**Attachment 9**  
**NRC3-12-0003**  
(17 pages)

**Response to RAI Letter No. 70**  
**(eRAI Tracking No. 6244)**

**RAI Question No. 03.07.01-7**

**Response to RAI Letter No. 70**  
**(eRAI Tracking No. 6244)**

Figure 2: RB/FB horizontal estimated 2% damped FIRS compared to the 2% damped spectrum for the RB/FB H1 SSI time history.

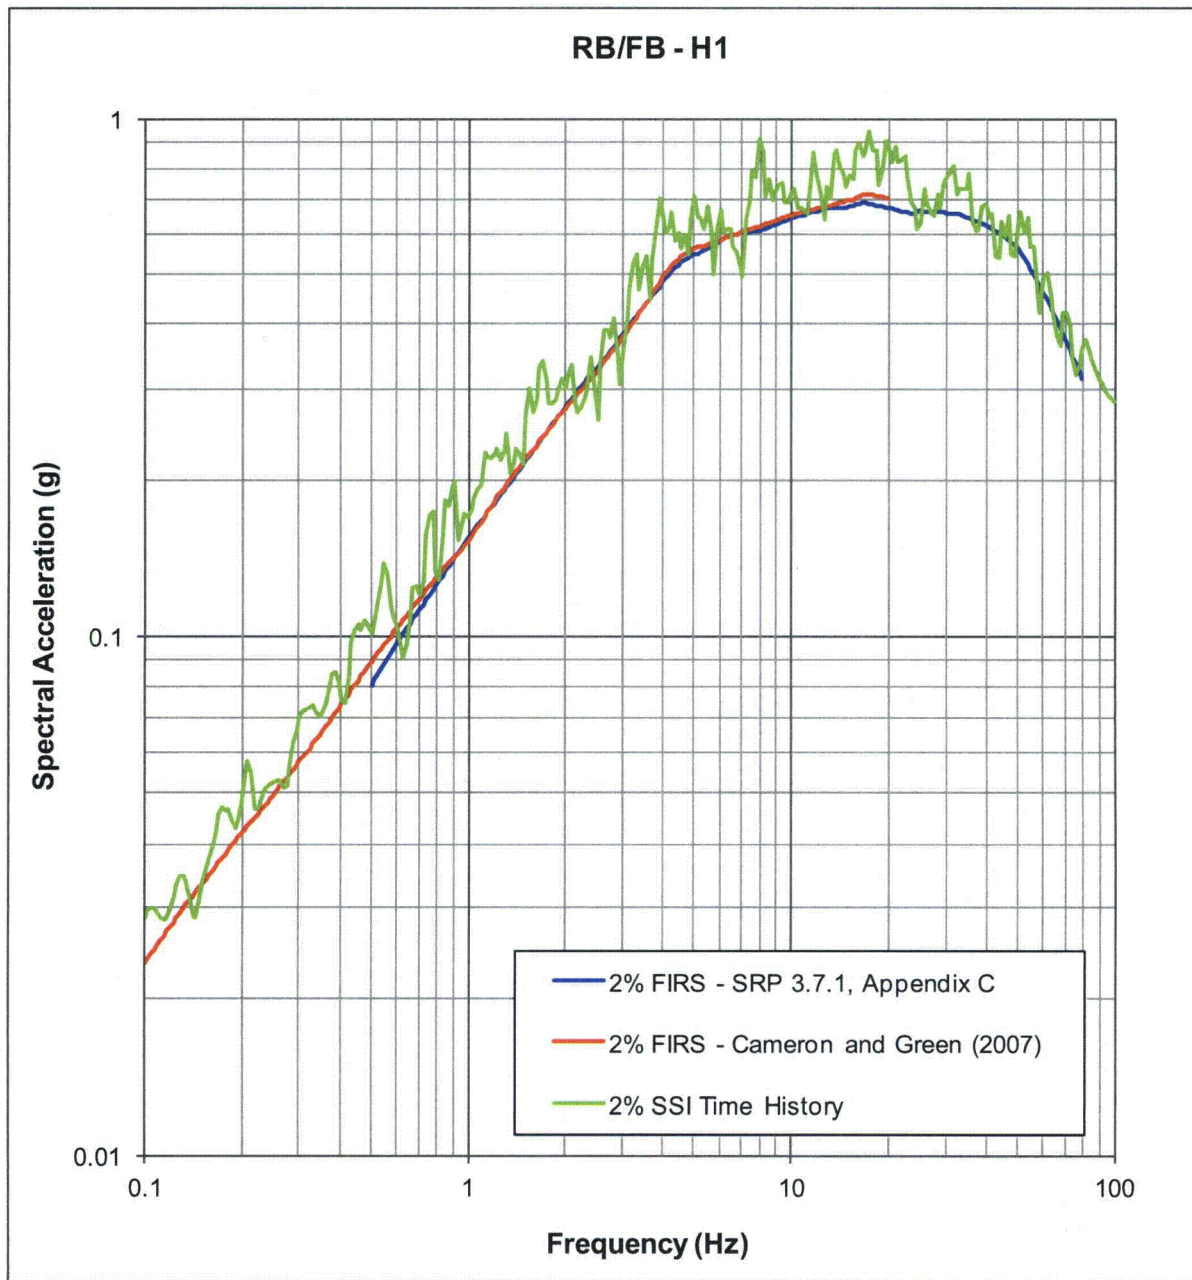
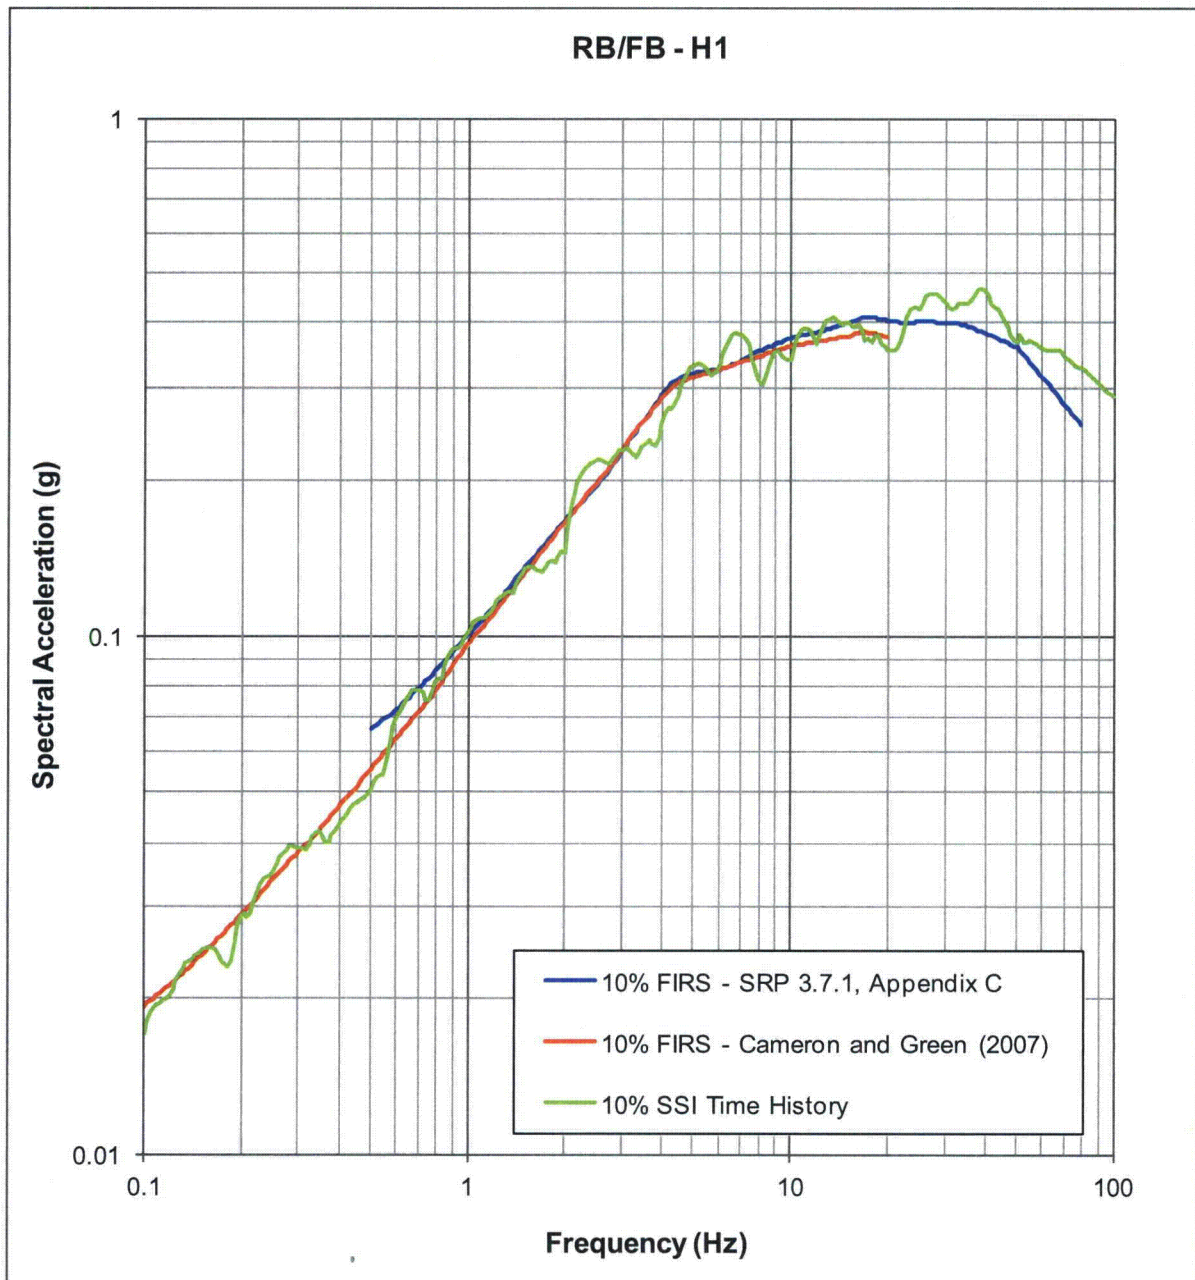
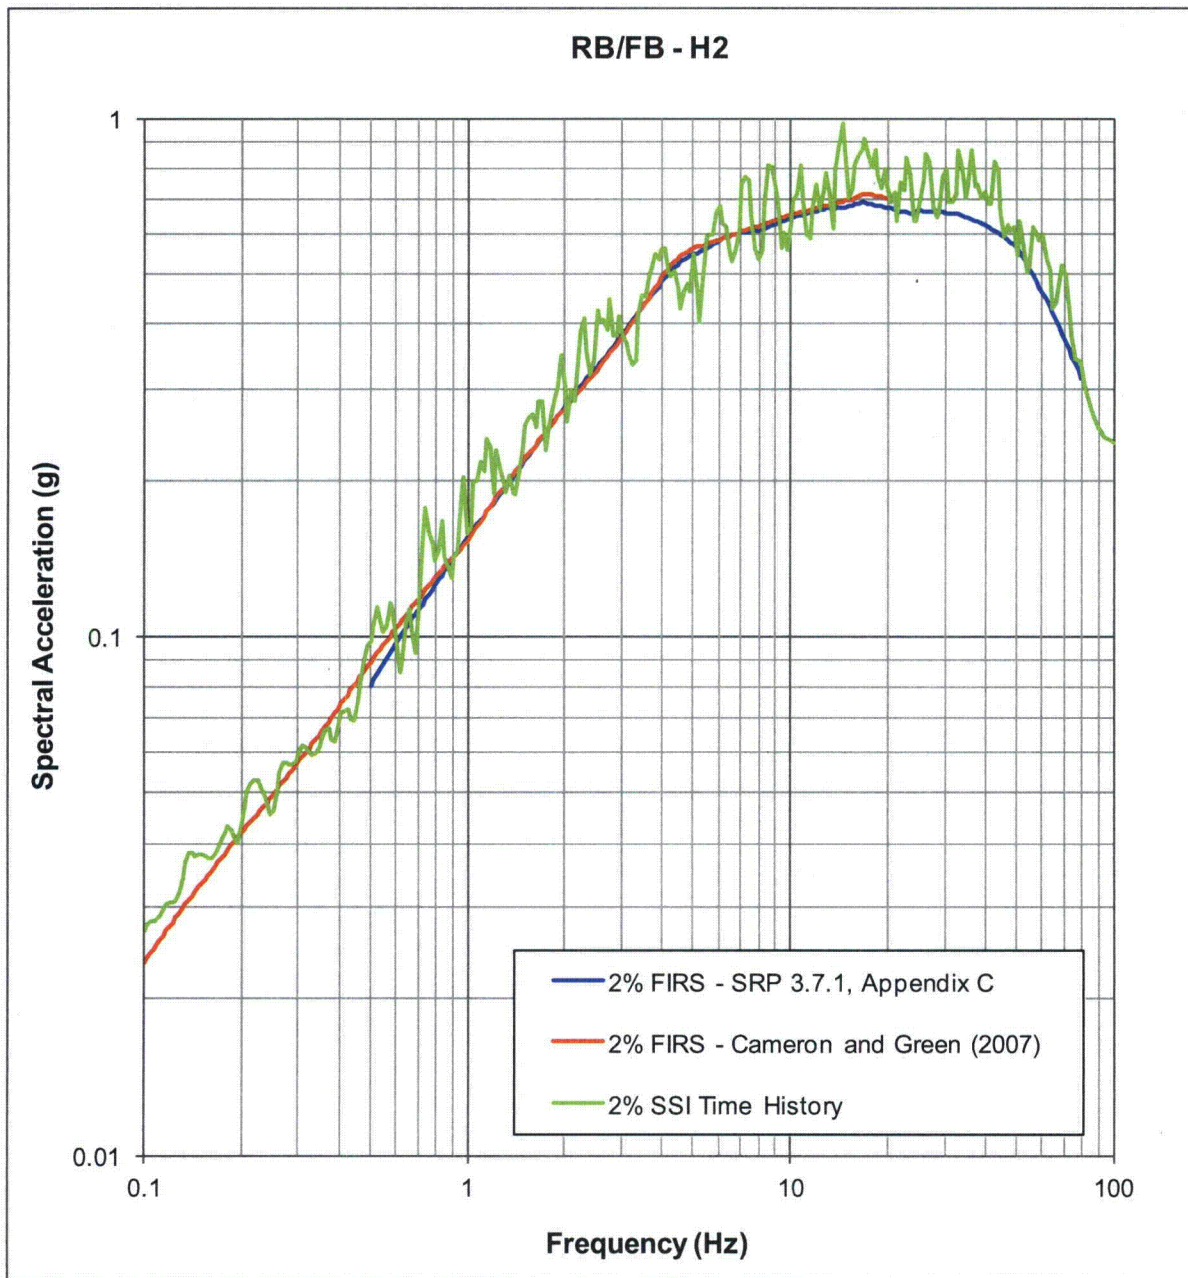
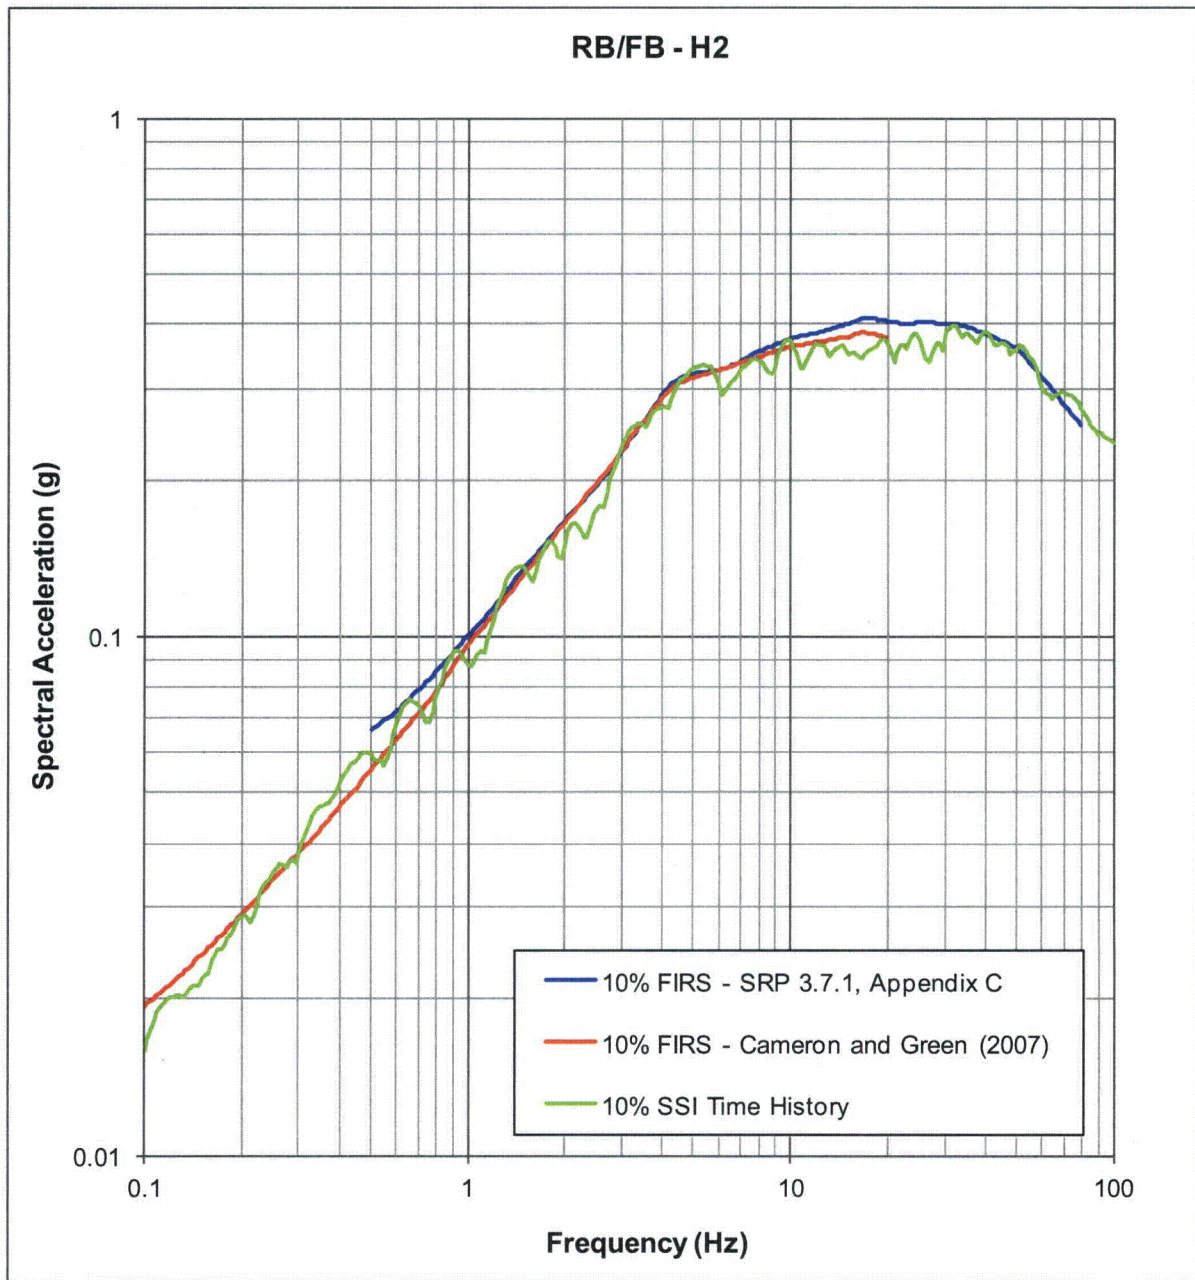
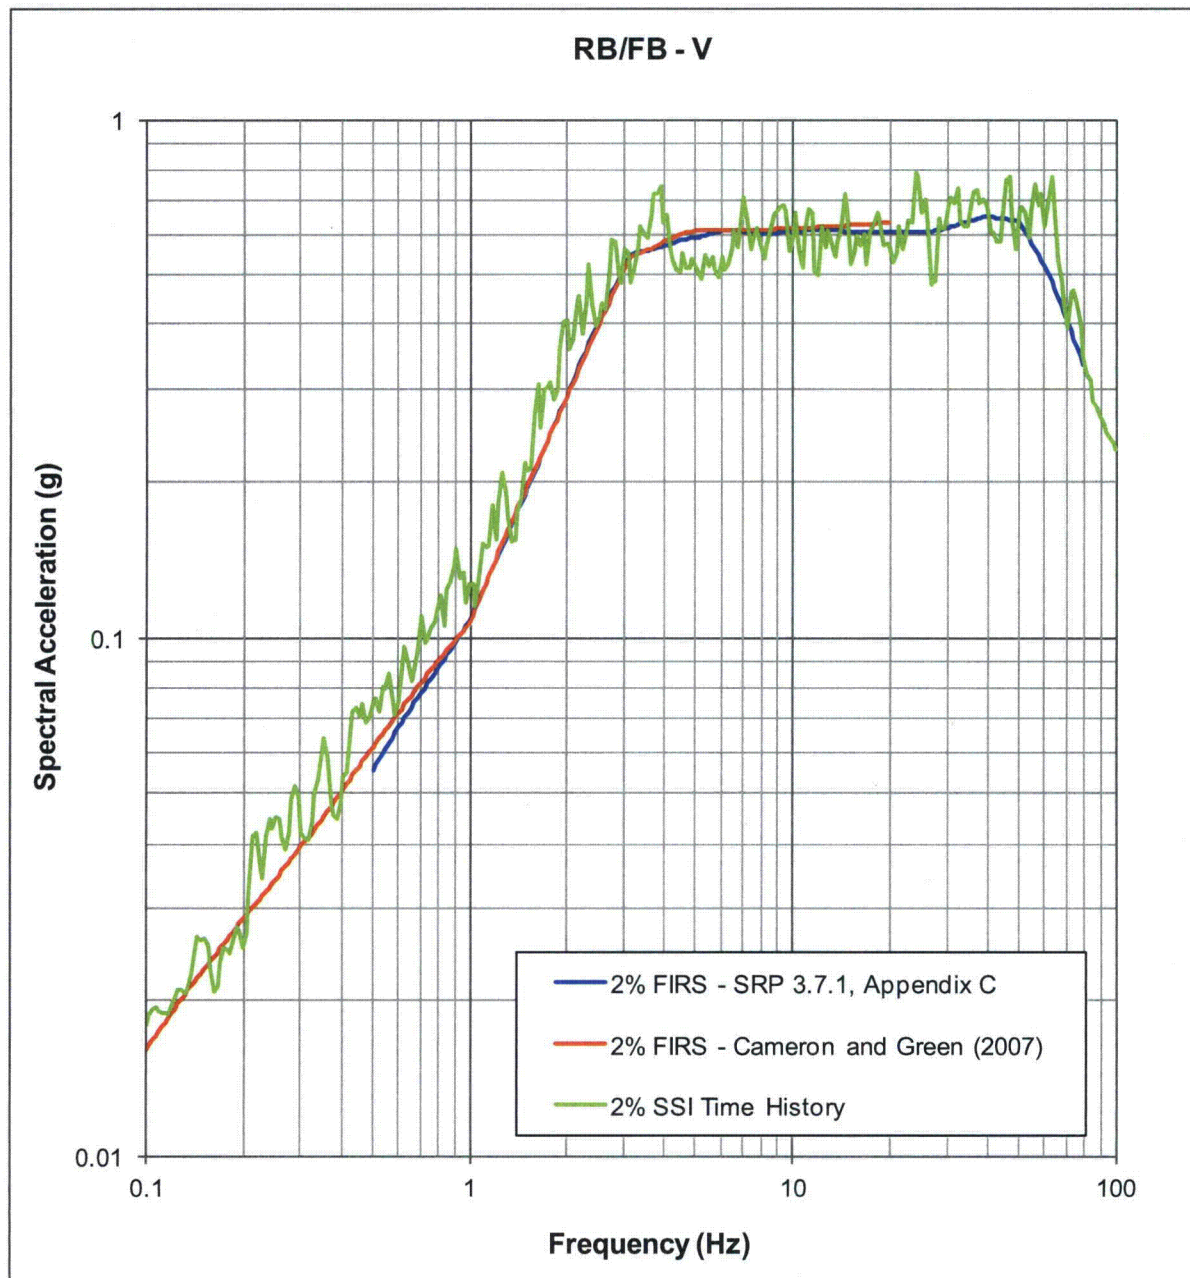
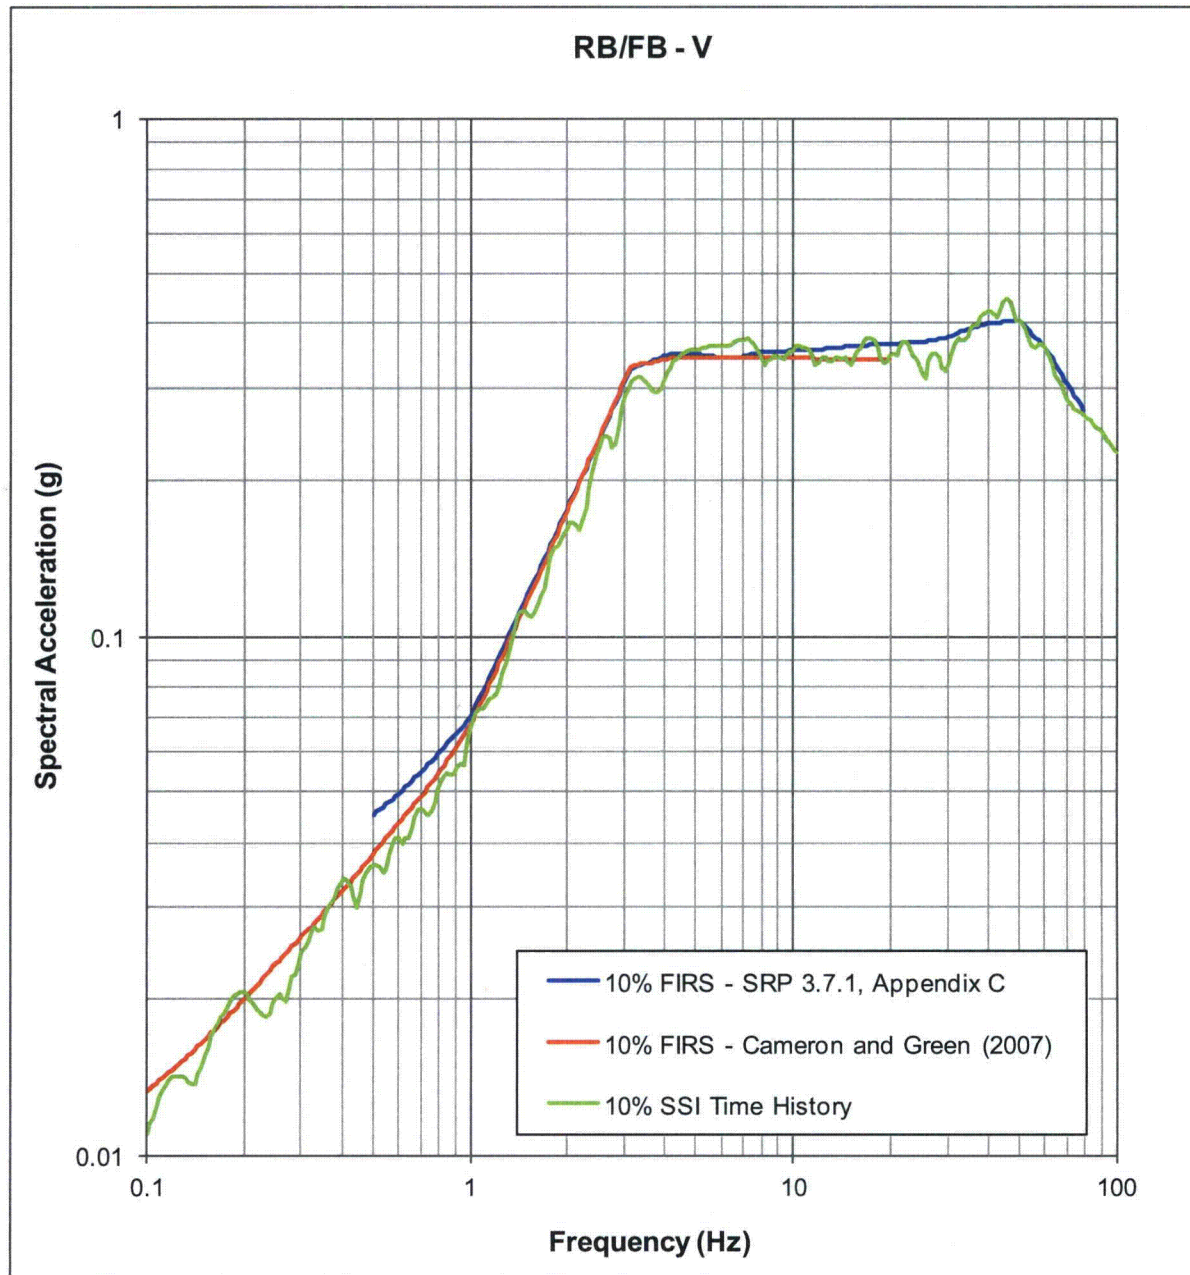
*SRP Acceptance Criteria 3.7.1.II.1B also specifies that PGV/PGA should be consistent with the characteristic values for the controlling earthquake. As such, the applicant is requested to provide further justification of the acceptability of the PGV/PGA values for the artificial time histories being higher than the selected controlling earthquake. The applicant is also requested to provide comparison of the response spectra of the artificial time histories and the estimated target spectra (SSI FIRS) at 2 percent and 10 percent damping values for RB/FB and CB.*

Figures 2 through 13 show the RB/FB and CB SSI FIRS scaled to 2 percent damping and 10 percent damping. Shown on each of the plots is the corresponding 2 percent or 10 percent damped spectrum for an individual SSI time history. The time history spectra are in good agreement with the scaled FIRS.
